STERN DRIVES/INBOARD ENGINES

service bulletin

NUMBER: 79-9

- A. Rochester Quadrajet Carburetor Idle Mixture Screw
- B. MCM 470 Voltage Regulator
- C. MCM 470 Dual Station Water Temperature Sender
- D. V-8 Engine Timing Chain/Sprocket Replacement

Figure 1. Idle Mixture Screw and Adjusting Tool

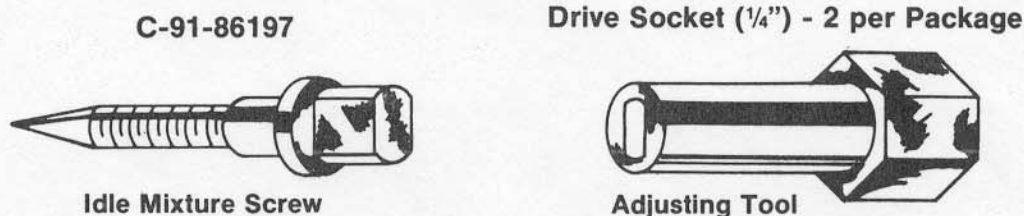
Rochester Quadrajet carburetors now incorporate a new style idle mixture screw with a "double D" head. (Figure 1) A special $\frac{1}{4}$ " drive socket (C-91-86197) is available for adjusting this screw.

B. EXHAUST ELBOWS USED ON LATER PRODUCTION MERCUISER MIE 230/260/340 ENGINES

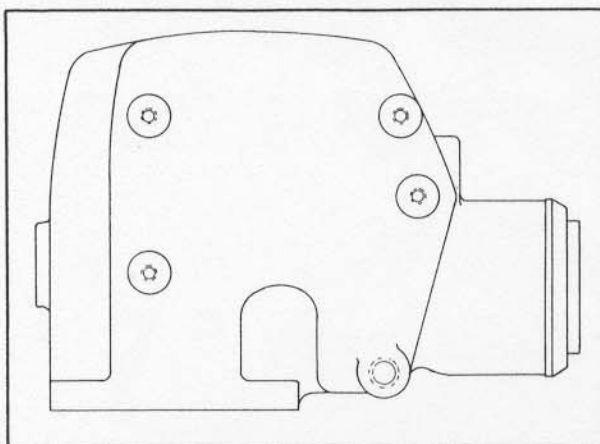
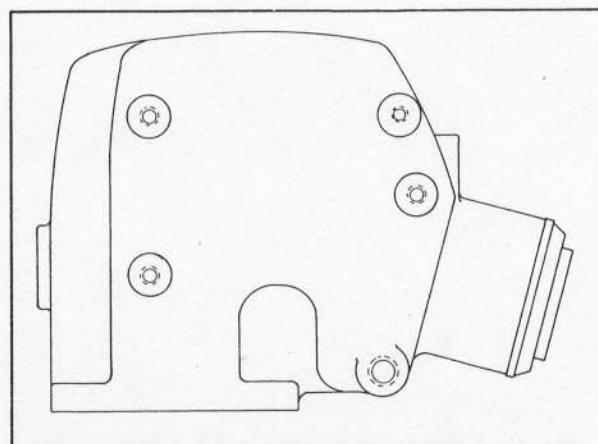
Replace all elbows, without the stainless steel tube, on the above model engines. Order the following below for each engine:

2	98502A2	0° Exhaust Elbow
	OR	
2	98504A3	15° Exhaust Elbow
2	27-87105	Elbow Gasket

98502A2 0° Exhaust Elbow.
Standard On Engines Equipped with
In-Line Transmissions

98504A3 15° Exhaust Elbow.
Standard On Engines Equipped with
V-Drive Transmissions. Optional On Engines
Equipped with In-Line Transmissions

Voltage Regulator Kit 99502A8

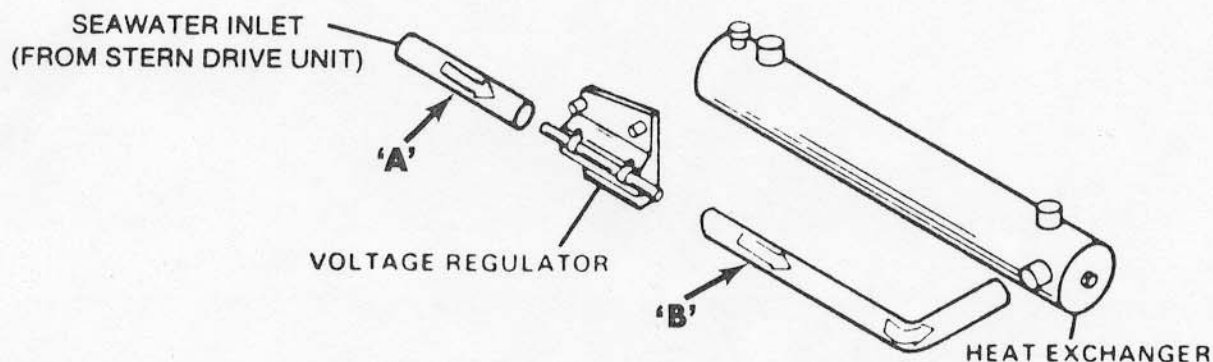
If recurring Voltage Regulator failures are experienced on engines equipped with an Ammeter Circuit, order Voltage Regulator Kit (99502A8). This kit contains the necessary parts and instruction sheet to convert to a Voltmeter Circuit. The Voltmeter gauge in the dash would have to be purchased separately.

Figure 1. New Design Cylinder Head

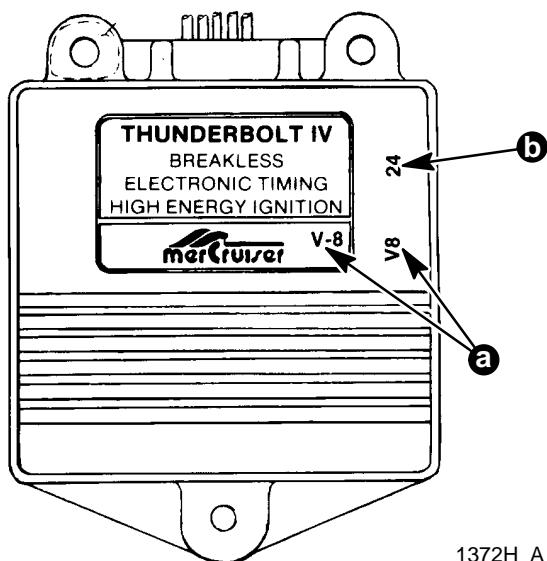
In August of 1986 General Motors made a design change to the 305/350 CID engines. Incorporated in this change was a new cylinder head design (Figure 1) and a different spark advance curve. Because the Thunderbolt IV HEI Amplifier controls the advance curve electronically, MerCruiser changed the advance curve of the amplifier to accommodate this change. In August of 1987 MerCruiser also had a cosmetic and electrical design change to the amplifier (Figure 2).

Figure 2. Amplifier Identification

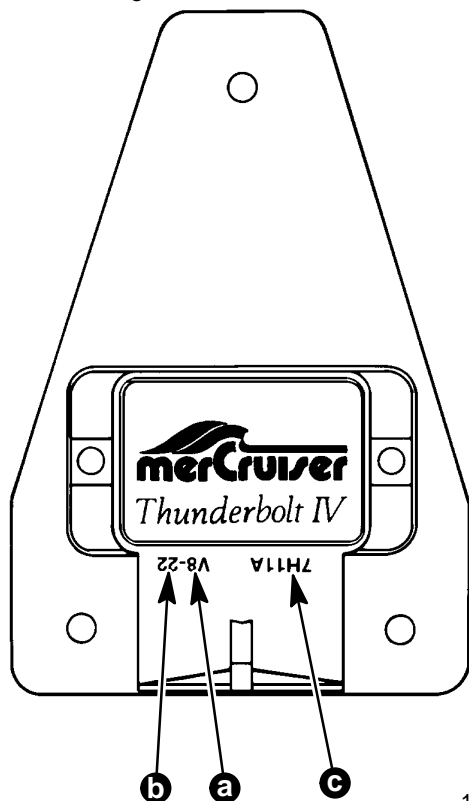
The old design amplifier incorporated either the 22 degree or 24 degree advance curve. The amplifiers are marked or stamped for the amount of spark advance (Figure 2).

The new design amplifier will supersede the old design by part number. Care must be taken to install the correct amplifier.

New Design
Figure 3.

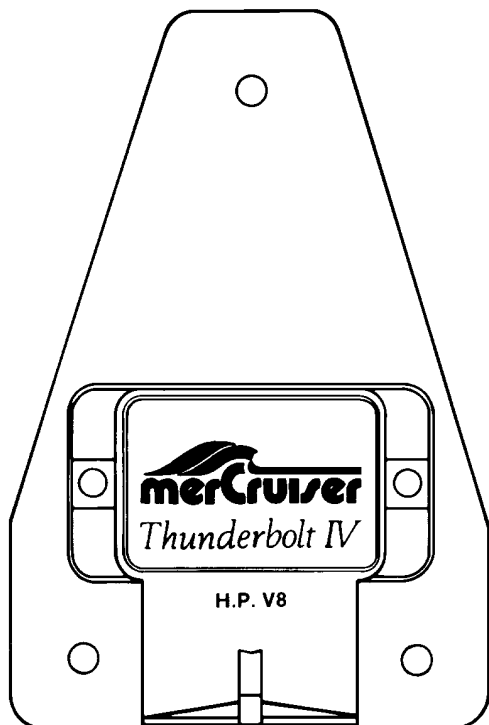
MerCruiser Performance Products is now using an amplifier (P/N 390-9571A1) with a revised advance curve on the HP 420/HP 575 engines. This change allows a better low RPM range performance through the advance curve. The initial timing must be changed using this amplifier. The new specification is 14 degrees BTDC.

Refer to Figure 3 for amplifier identification.

Early HP 420/HP 575 engines used amplifier (P/N 390-7804A3). When servicing these engines, or replacing the amplifier, the new amplifier can be used. The initial timing must be reset. It is recommended that the old amplifier (P/N 390-7804A3) not be used on the earlier engines if amplifier change is necessary.

Figure 2.

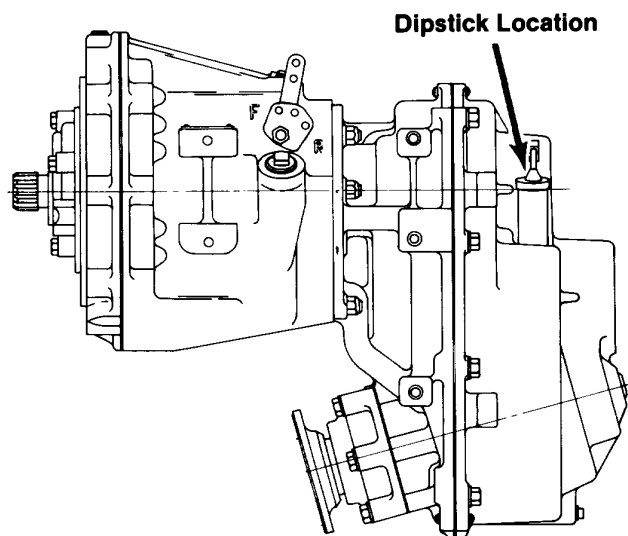
Borg Warner V-Drive transmissions with dipstick located in V-Drive case (Figure 2) that have had intermediate shaft rear bearing failure should have oil capacity increased.

Dipstick 10-05-559-001 (Figure 3) is now available for use in Velvet Drive® V-Drive transmissions which have the dipstick in the V-Drive case. The new dipstick will provide for additional oil capacity. Order new dipstick from your closest velvet drive distributor as shown on map. The following illustration shows the dimensions of the new dipstick. It is recommended that the new dipstick be installed when servicing any V-Drive transmission which has the dipstick located in the V-Drive case.

Original dipsticks can be modified to current design by adding a mark 1" (2.5mm) above the original "full" mark. The original "full" mark then becomes the "low" or "add oil" mark.
